Response to Worcester LCWIP

Network consultation

October 2025

Network consultation - Bike Worcester

Route I (Primary) - Fernhill Heath to Foregate Street

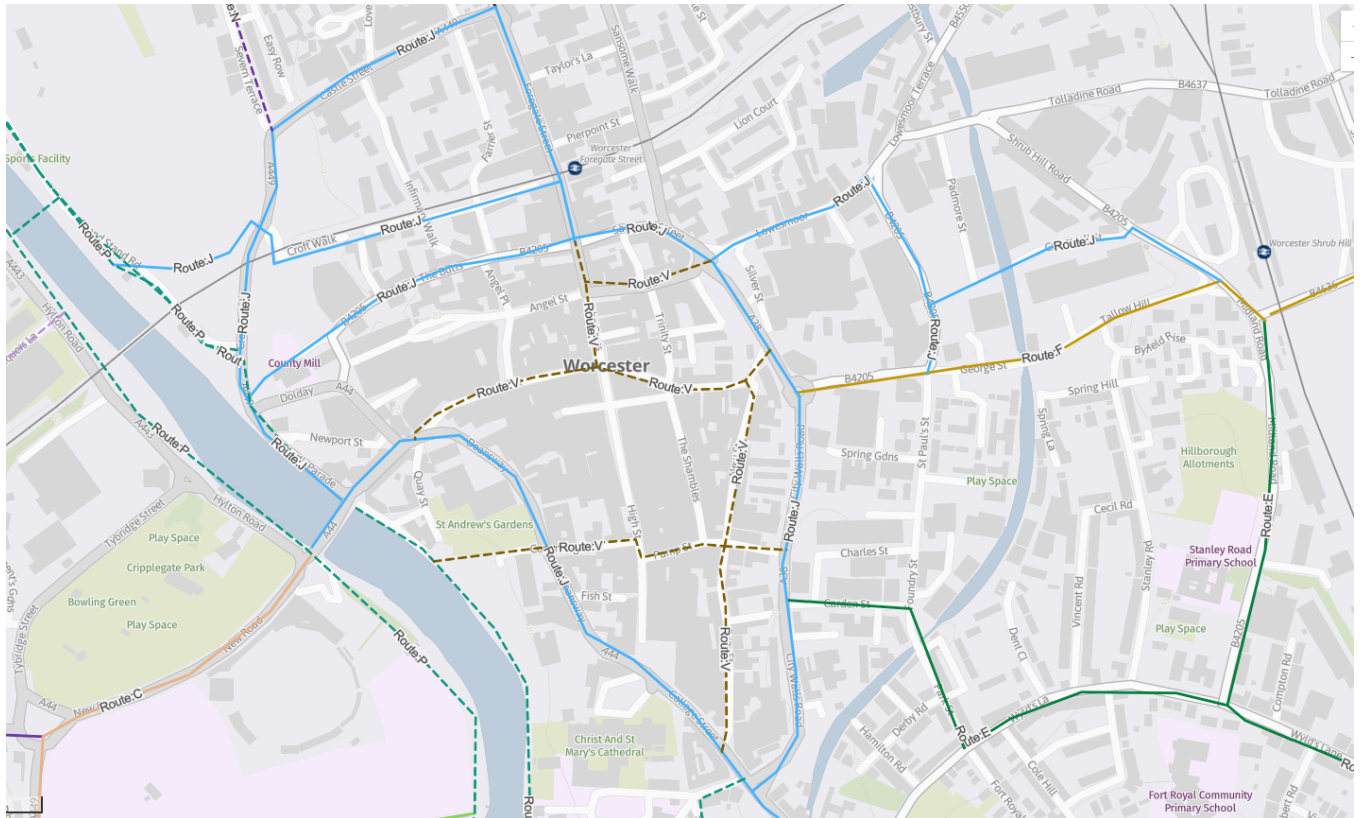
We agree this is needed as a primary route. We would expect a good quality route would be well used by the community.

Rob C	I strongly support Fernhill Heath to Foregate Strt: it has the potential to form a vital active travel corridor from the North and can provide a spine for other routes to connect to (as shown in the proposed network plan). Road width is sufficient along the entire route for segregated cycle lanes for large stretches. There is high demand for active school traffic on this route (as demonstrated by multiple bike buses that operate in the area). Suggestion: convert the existing bus lane on Tything into a bidirectional cycle way.
Ian FW	I support this route. It connects multiple schools, and multiple POI along what is currently quite a dangerous stretch for cycling (especially between John Comyn Rd and Fernhill.) I cycle this route twice a day and see kids cycling on the pavement. Making space for them to be safe would be brilliant and would encourage more. I am very strongly of the opinion that for this to be a successful route it needs to be segregated (physical/kerb) along its entire length, certainly the northern component, where the minimum existing road width seems to be about 8m, on average much wider. There are also multiple junctions on this road where bike lane priority is needed, otherwise these junctions are too busy for cyclists to cross (e.g. setbacks as per LTN 1/20 Fig 10.13). If this were to only be painted lines, then it would not be safe (esp for kids) and would not get the use to make it successful. Big fan of this route, would love to see it delivered properly to connect North Worcester to Foregate.

Dan B	Essential link to Fernhill Heath and the city, and onward link to Droitwich. Plenty of space on the road for a fully segregated route. This should however be extended to include a route North South through the city centre as a primary route. In it's simplest form change to TRO that prohibits cycling and mobility scooters temporarily, until a permanent North / South route is designed. CROSSING THE CITY CENTRE NORTH / SOUTH AND EAST / WEST IS THE BIGGEST PRIORITY!
Wilf	Support implementation of Route I - a critical link north from/to the centre. Huge potential for segregated lanes along the length; need cycle priority at traffic light junctions and roundabout.

Route J (Primary) - City Centre Loop

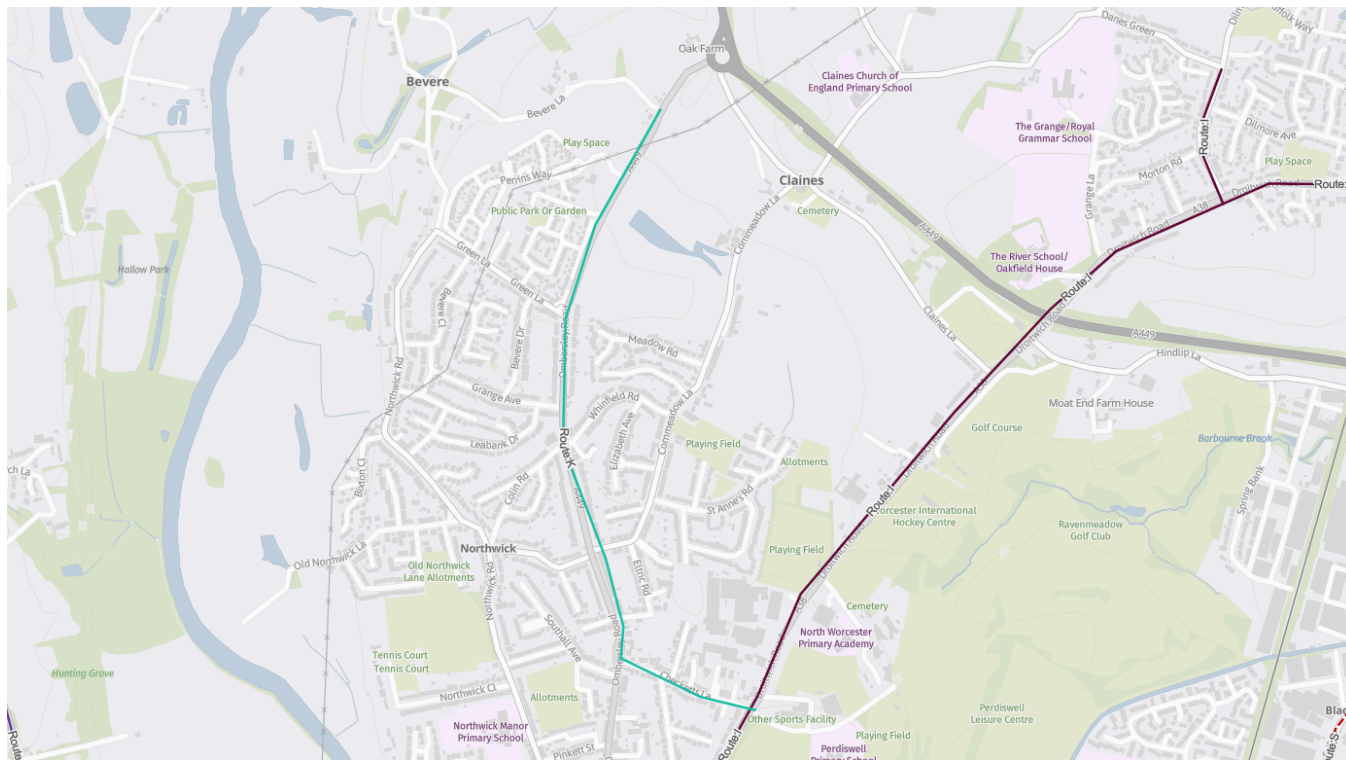
We agree this is needed as a primary route. We would expect a good quality route would be well used by the community. Prohibition of cycling in the city centre is a huge barrier to cycling rates. It is essential that routes across the city centre from all directions are established as soon as possible. We would envisage a combination of this route and route V as being considered highest priority.

Chantal	I support the use of New Street as a low pedestrian traffic alternative to the high street. However there are currently
---------	---

sections that are one way (in two different directions). Cyclists would need to be allowed to travel in both directions for the length of the street for it to be feasible. Blocking New street to through motor traffic so it could be used to enter (if necessary) and exit the multi-storey parking, but not used as a shortcut to city walls road when the lights are red, would also significantly reduce the volume of traffic here.
James N	Currently, I think it is unclear that Worcester Bridge is a shared use path. If that is the plan going forward, this needs to be made more clear to avoid conflict between the two users. I think making Deansway more safe for cycling and pedestrians is important. You have 4 separate college buildings and a music school on that road, but bike parking is often mostly vacant. I think this is because having to navigate the 4 lanes of fast moving traffic (including coaches, trucks, etc.) puts people off. The new cut through that passes by the Arches is much appreciated by those of us who use the train.

Dan B	Route V is the priority, this should be secondary.
Wilf	I support Route J, the northern element of which is an important link between the riverside/west Worcester and Shrub Hill and beyond. This element is identified as a Phase 2 project in the City Centre Transport Vision. It is part of a strong linkage between Shrub Hill and Foregate Street stations; it feeds into onward-links between the University's city centre Campuses and St John's/Arena campuses; it makes effective use of the Transport Vision's proposals for Lowesmoor and its enhanced junction with Sansome St etc.. Along with Route V it provides a vital improvement to permeability in and around the City Centre. Worcester Bridge could be reconfigured, closing one vehicle lane westbound to provide a 2-way cycle lane and relieving pressure on the southern footpath, which is currently a narrow shared pedestrian/cycle route.
Fleur	Getting from Deansway to NParade means one has to change lanes to get to the righthand lane for filtering to NParade, which can be challenging when busy. A cycle box at the All Saints Rd crossing would be very useful. Getting onto NParade is also quite challenging. This 'desire line' (for crossing NParade) could do with a pedestrian crossing which could also help cyclists. Going in the other direction the narrowing of the road by Malthouse Pl. often results in uncomfortable close passes.

Route K (Primary) - Bevere to Droitwich Road

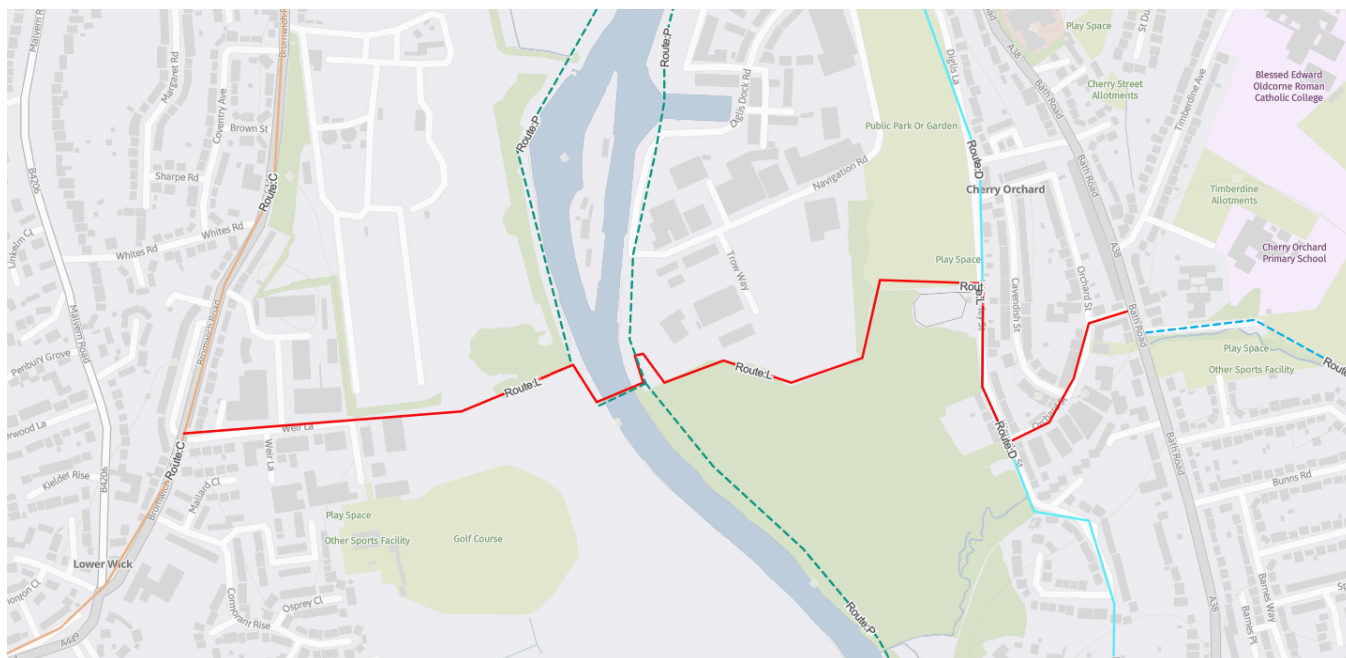
We agree this is needed as a primary route. We would expect a good quality route would be well used by the community.

Dan B	I already use this route as shown, but am also happy using some of the NCN that runs parallel(ish) to the left of it (which could be improved). Why aren't they shown?
-------	--

Route L (Primary) - Lower Wick to Cherry Orchard

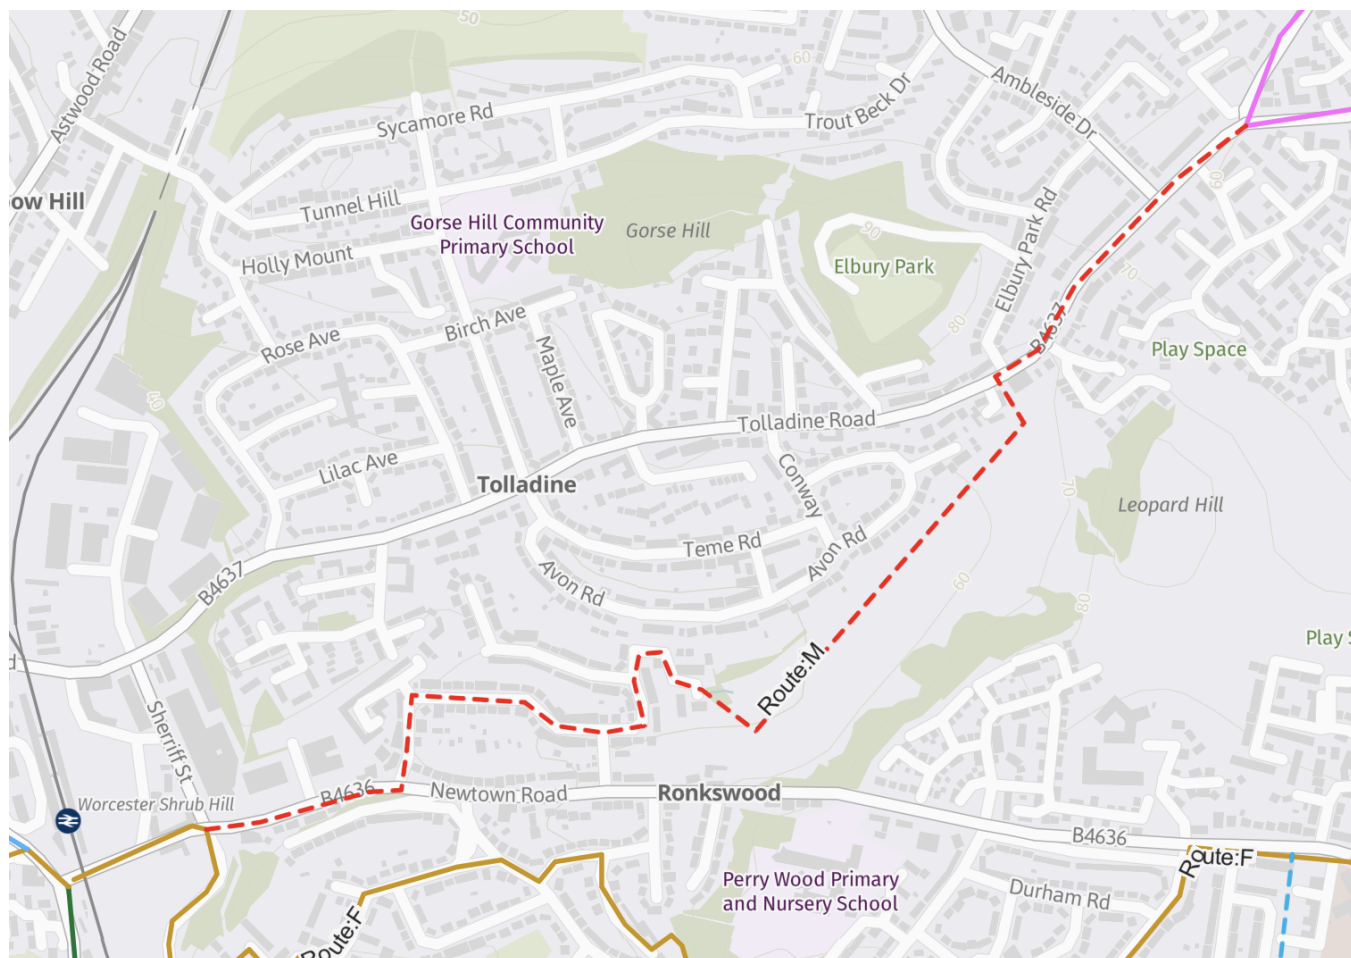
We think this is a positive suggestion as much of the required infrastructure is already in place, however we do not think it is a primary route. Whilst improvements could be made, we do not believe it should be a priority.

Al P	On the Lower Wick side, it is unsafe to join Weir Lane from the south, as cyclists are forced to merge into oncoming traffic that is hidden from view. When approaching Bath Road, a safer alternative is to use the path through St. Martin's Church car park, which is already signposted as a cycling route but is not marked on this map. The primary issue with this alternative route is its lack of maintenance. Although the path is wide enough for shared use, it is
------	--

frequently overgrown and requires regular clearing to remain accessible for everyone.
Dan B	All of this already exists as a well used route. Shouldn't this be a separate category (eg. existing route, needs minor improvements)?
Chantal	This is a route that I used from St. Peter's as far as Lower Wick swimming pool for years. However, when the river Severn is flooded it is impossible to access. Flooding has become more frequent in the last ten years so this route is not accessible all year round. We also used the crossing by St. Martin's church however the lights there are extremely slow to change.
Fleur	As mentioned above this route is regularly unavailable due to flooding.

Route M (Secondary) - Shrub Hill to Warndon

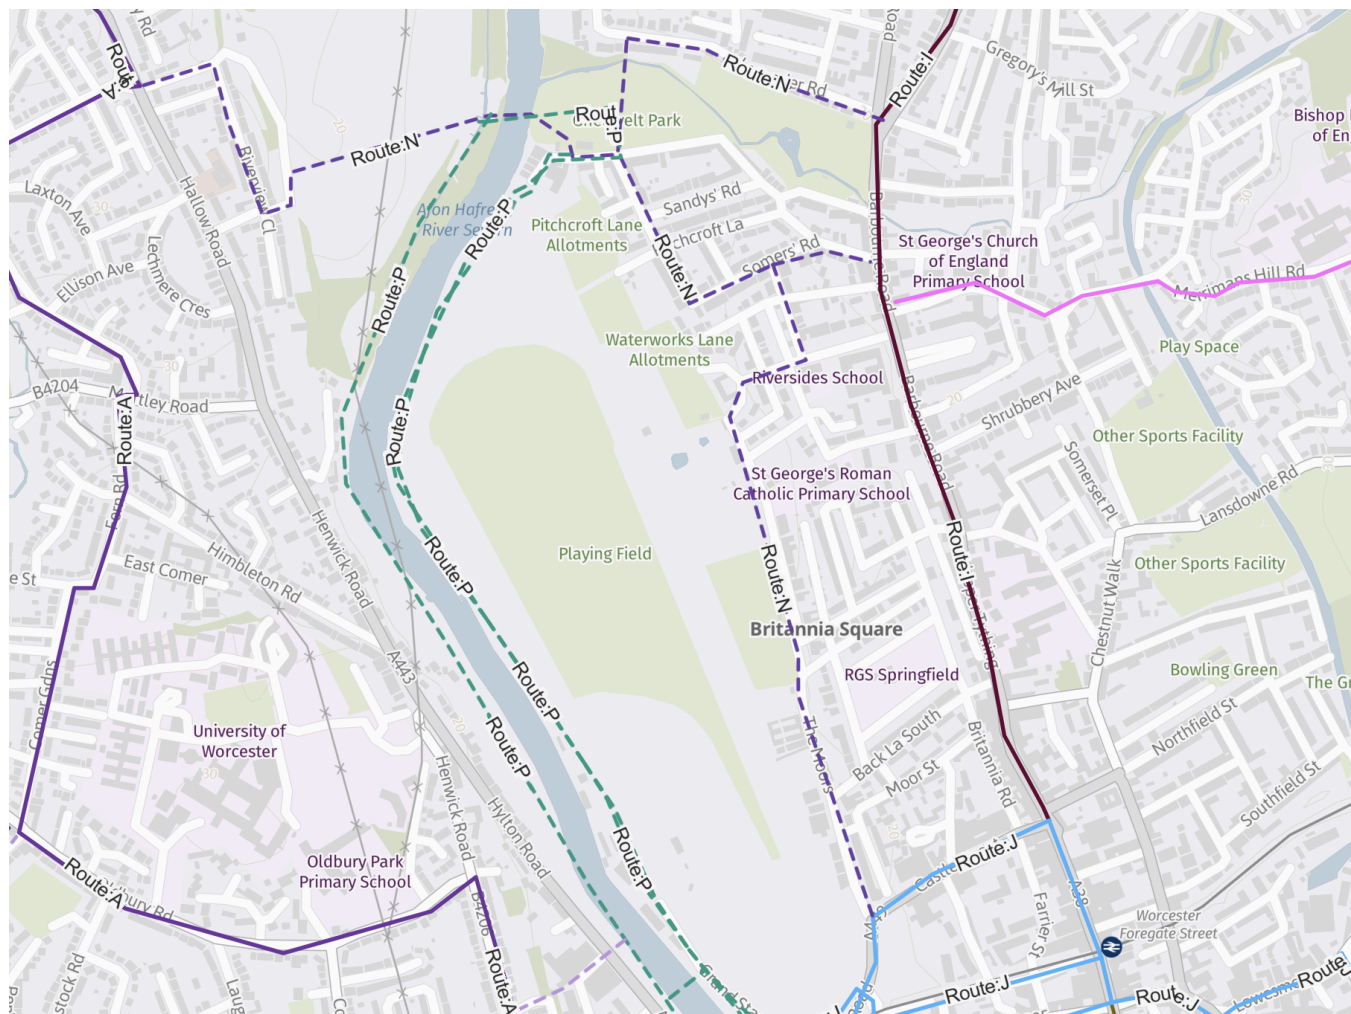
We think this is needed as a primary route. The proposed route is not sufficiently direct. We would expect a good quality route would be well used by the community.

Fleur	At the western end of this route you really don't want to have to get onto newtown road, as it is not suitable for average cyclists. Also leads into newtown rd tunnel which is not cycle friendly (especially from n-s direction).
-------	---

Route N (Secondary) - Hallow Road to city centre via Kepax Bridge

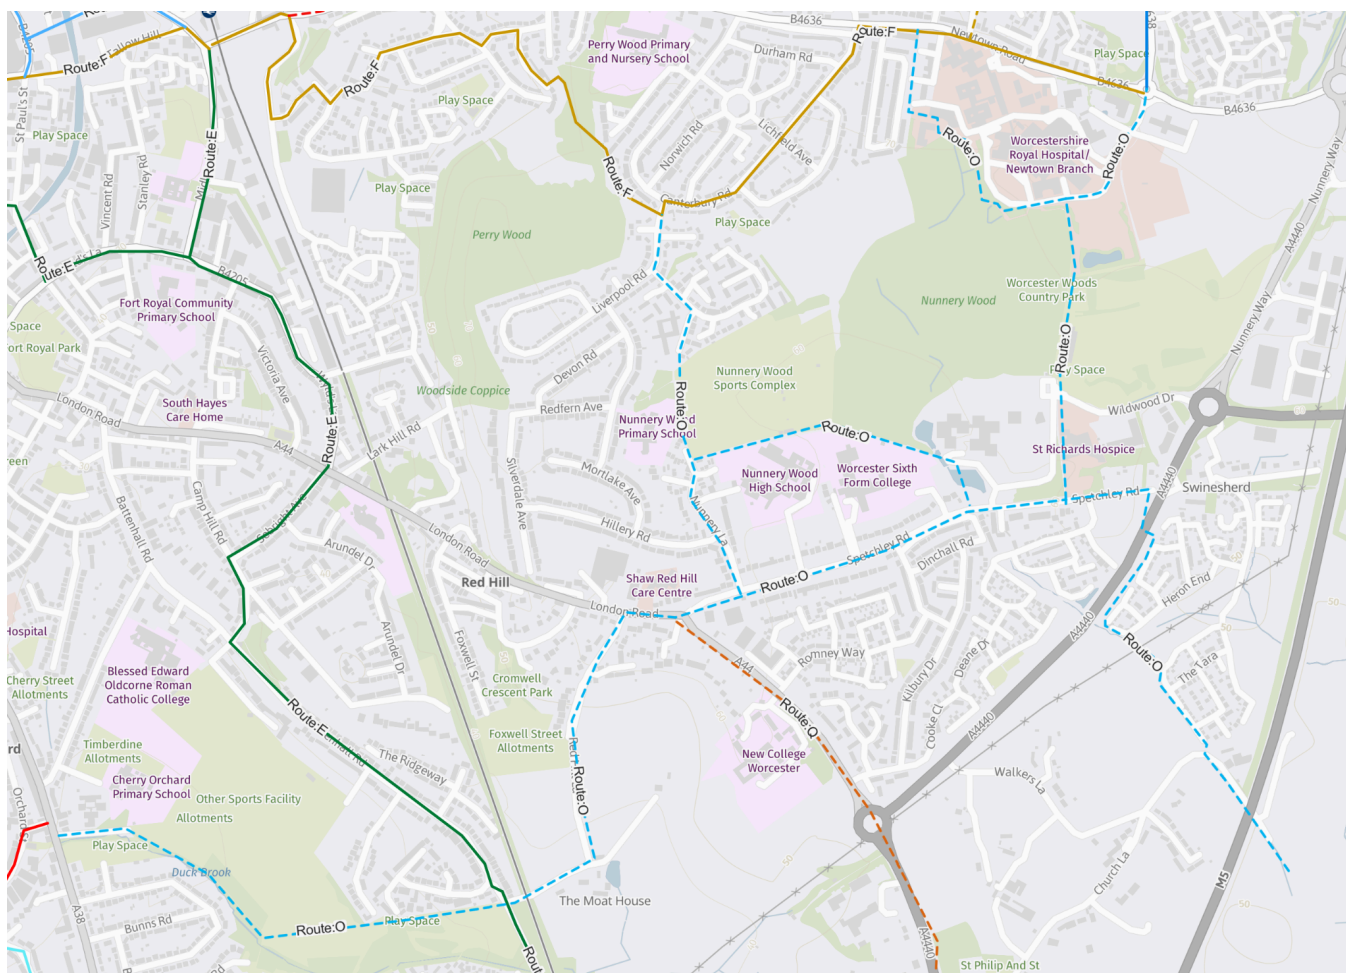
We agree this is needed as a secondary route with improvements in place. The route is already well used by the community.

Wilf	Support
------	---------

Route O (Secondary) - Cherry Orchard to Worcestershire Royal Hospital

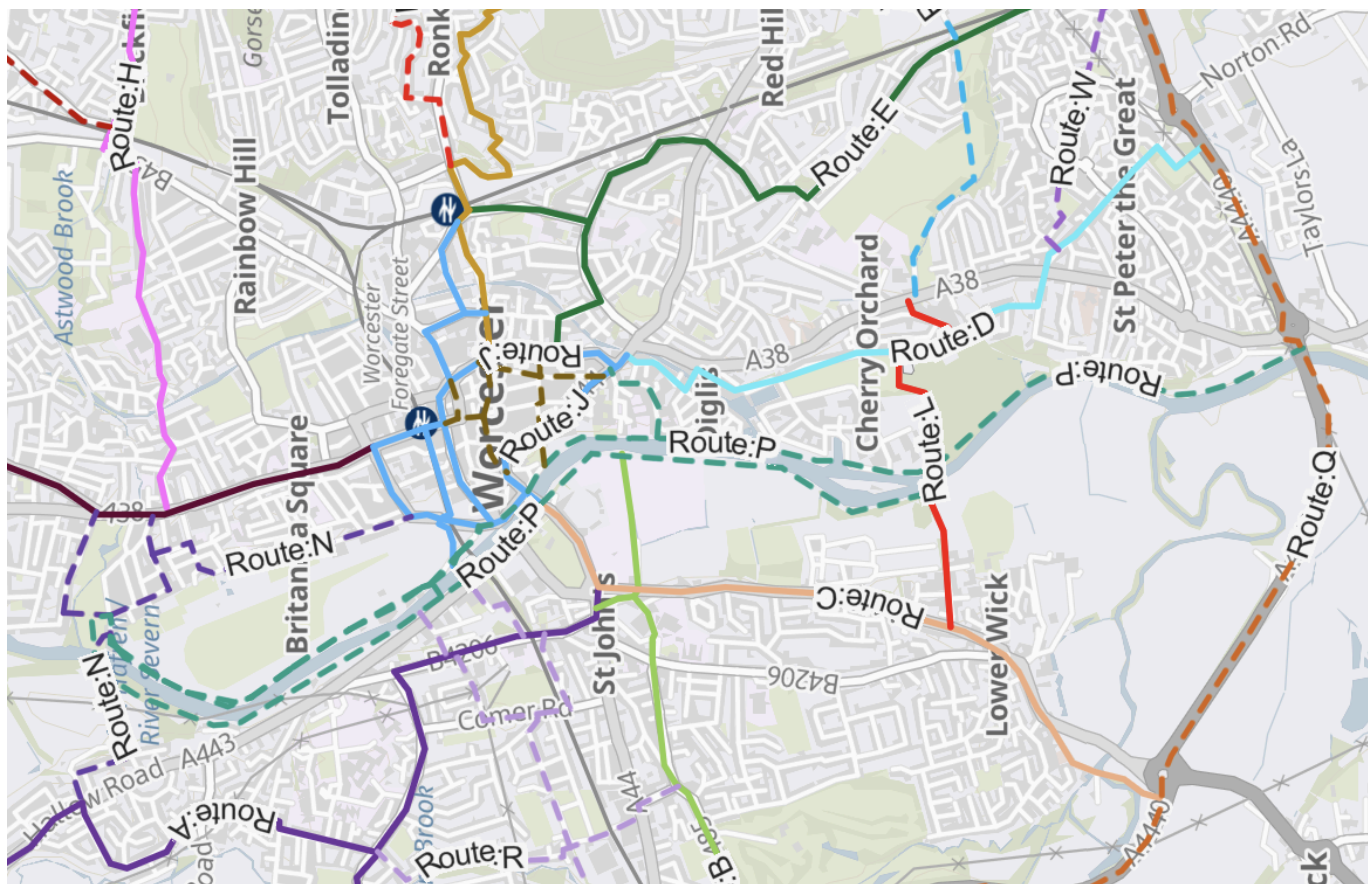
We agree this is needed as a secondary route with improvements in place. The route is already well used by the community.

Chantal P	The route from St Peter's to Spetchley road needs a solution at the crossing to enable cyclists to cross as well as pedestrians in both directions. At the beginning and end of the school day, the pavement and road is extremely busy.
Fleur	The Red Hill lane section can become difficult to ride due to rill erosion. The top end of this section is also extremely steep. Along the Battehall Park and Duck Brook section of this route it is unclear what is the cycle lane and what is the pedestrian lane. This often leads to conflict with pedestrians (especially dog walkers). The section near Cherry Orchard school is particularly impossible to ride during school drop off/pick up times as pedestrians use the full width of the path. Spetchley rd can be extremely busy at times and navigating the oak apple roundabout by bike is not for the faint hearted. Would be good if cyclists. Better arrangements for cyclists to use crossings would be helpful.
